MEMORANDUM

SUBJECT: 2023 Road Program Tree Evaluation

2023 ROAD IMPROVEMENT

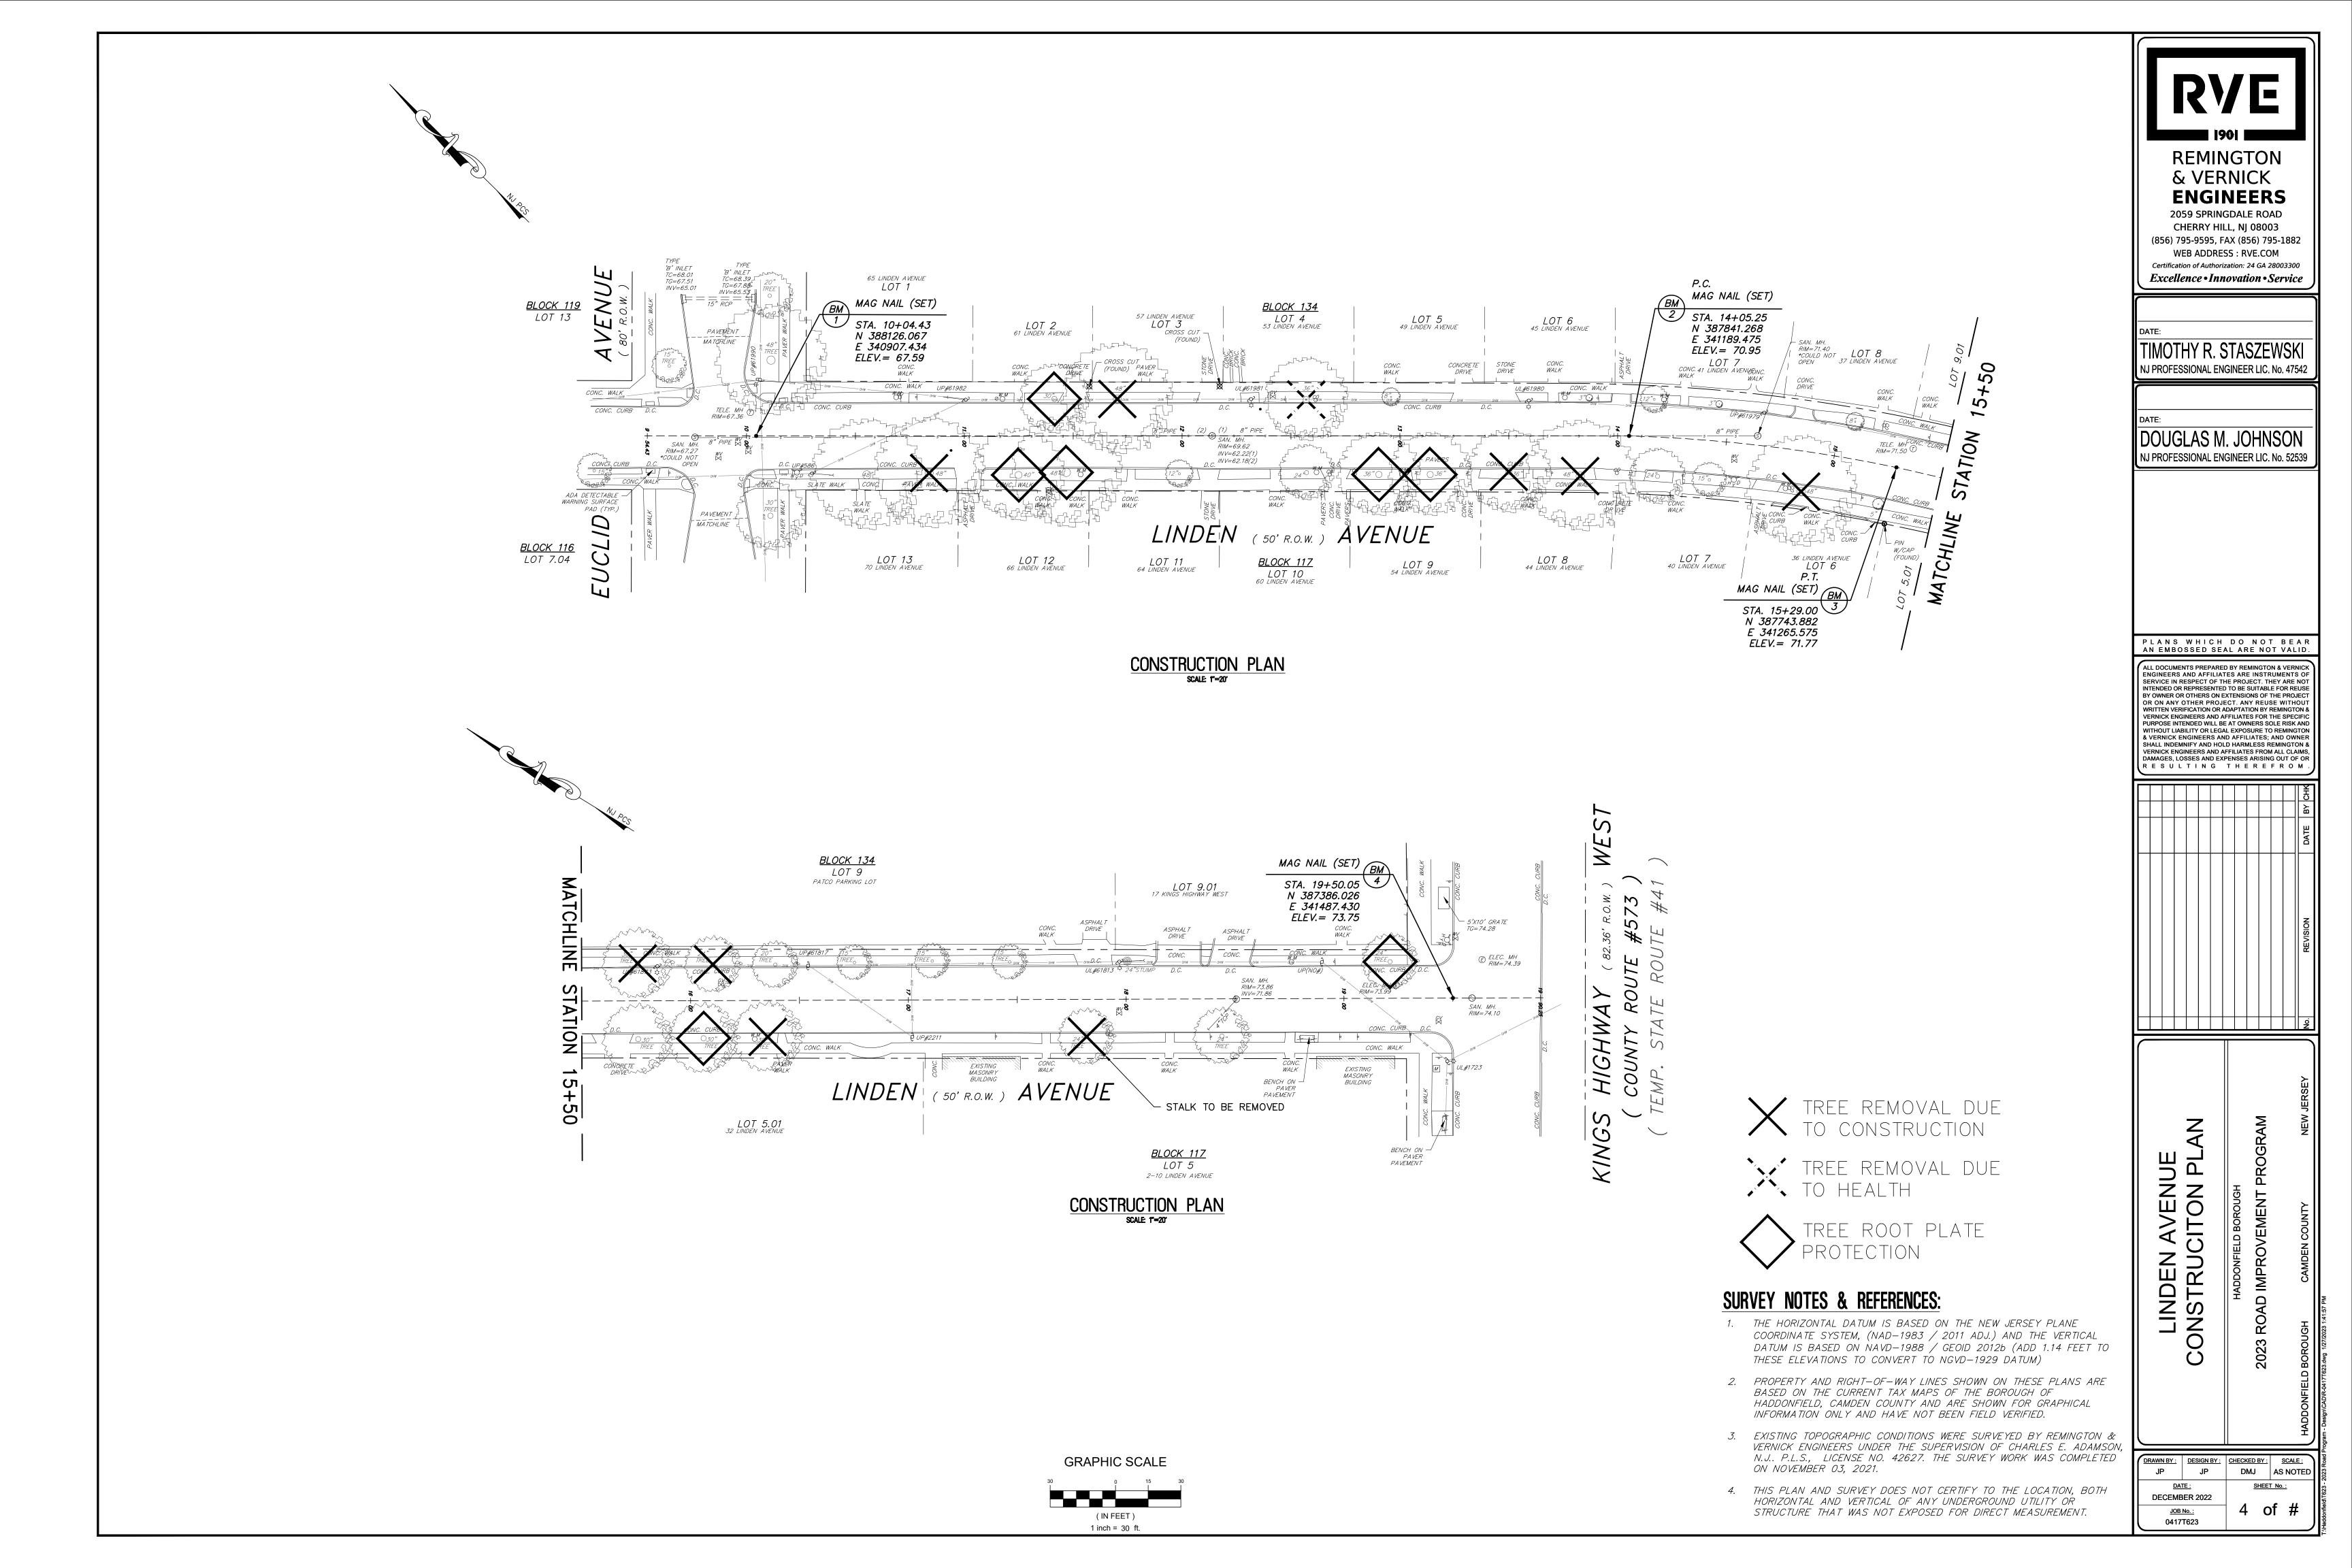
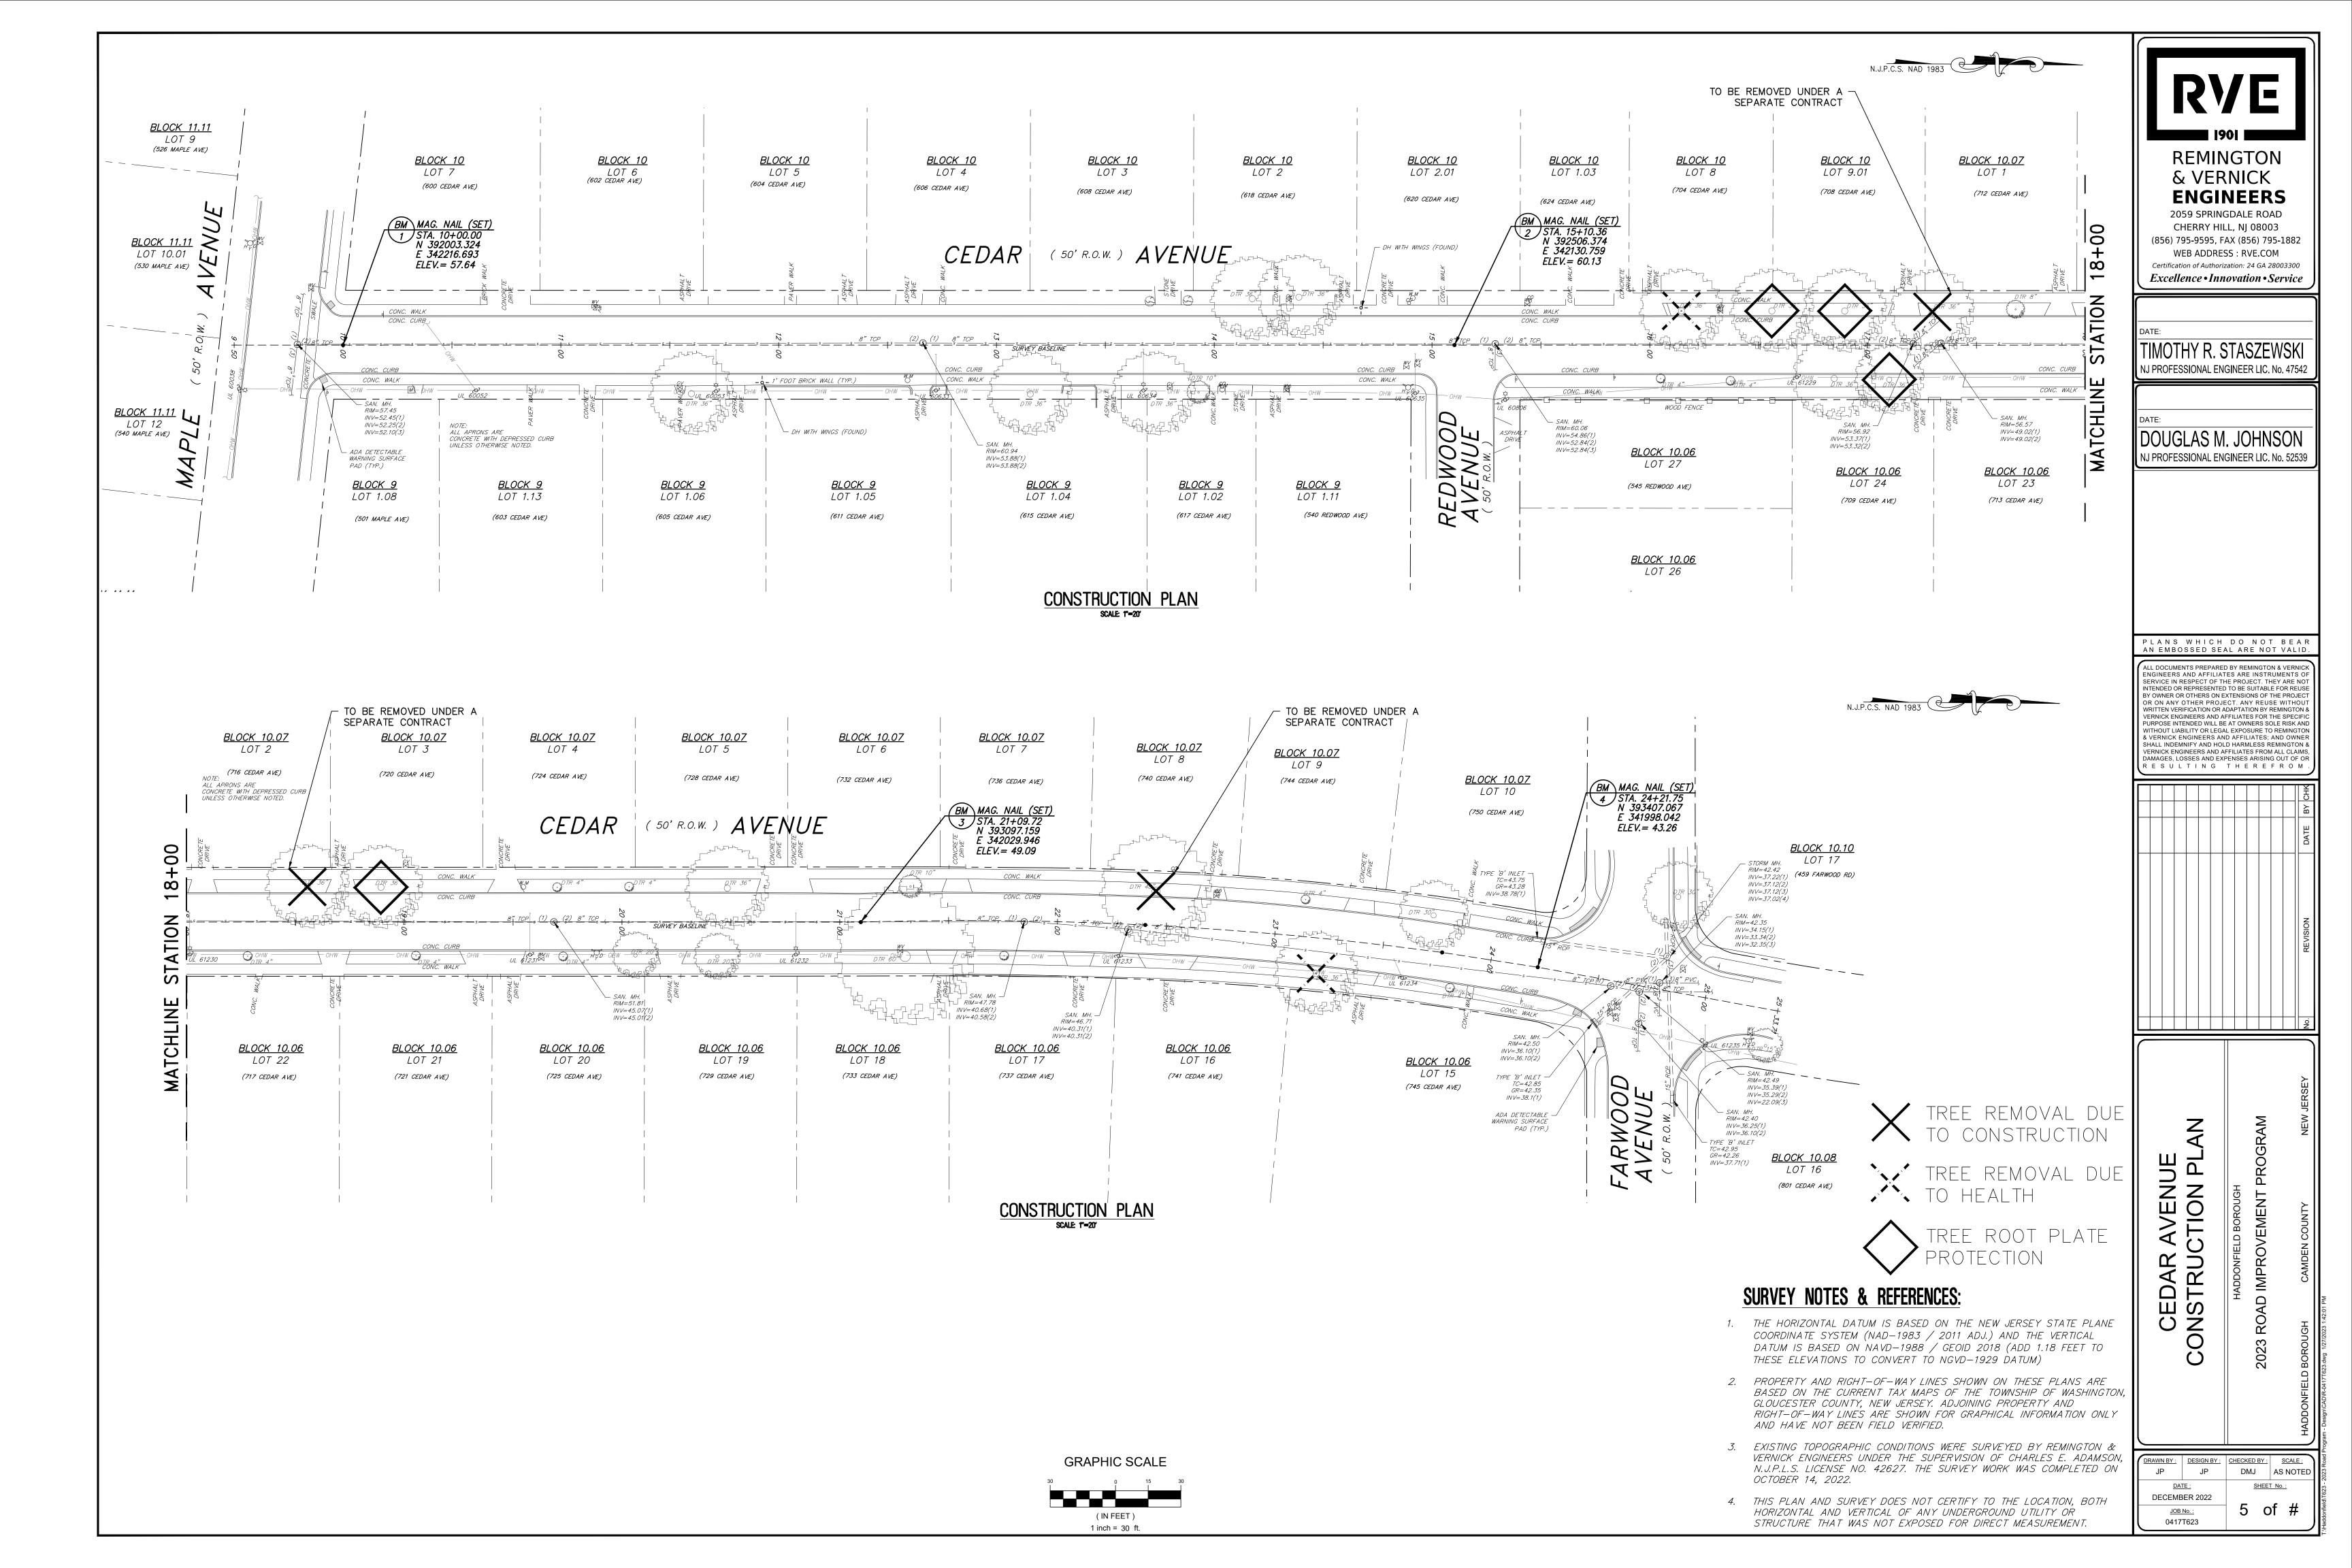
17 Lafayette Avenue 40" Red Oak (F1) is in good condition and overhangs part Tree to be removed due to construction

of the curb and road

19 Layafette Avenue 24" tree with roots Tree to be removed overhanging the curb and due to construction

pushing the curb out
